DEPARTMENT OF
ENVIRONMENTAL
QUALITY

> Re: OSS-Clatsop County Alteration Permit Permit # 90-157 T6N, R10W, S10BD, TL 700

Our Department has received your application for the alteration of an existing on-site sewage disposal system. The existing alternative pressurized seepage bed is to be constructed to include an additional 200 square feet. This will bring the bed square footage to 600 square feet, which will accommodate up to a 4 bedroom single family residence. The following items listed below are required before we can approve the alteration of the existing 400 square alternative pressurized seepage bed.

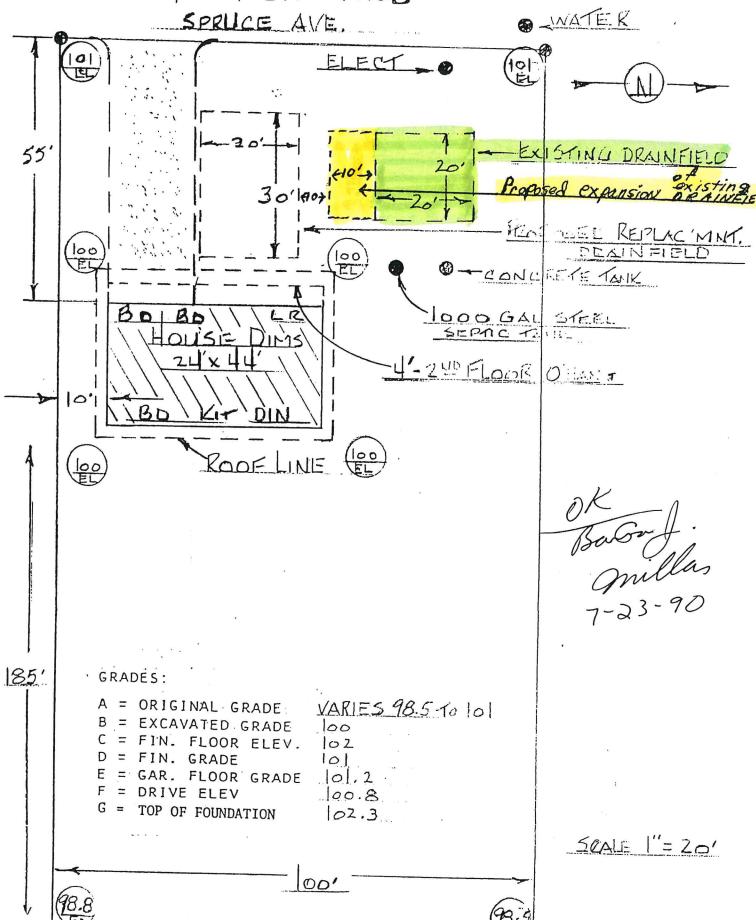
The as-built plot plan shows the distribution laterals running west and east. The seepage bed is shown to be altered on the south side. In order to extend the pressure pipe onto the ends of the pressurized distribution laterals the pressurized seepage bed would have to be altered on the west side. One other possibility is to add onto the manifold to obtain the additional 200 square needed.

Please include this information on the as-built plot plan.
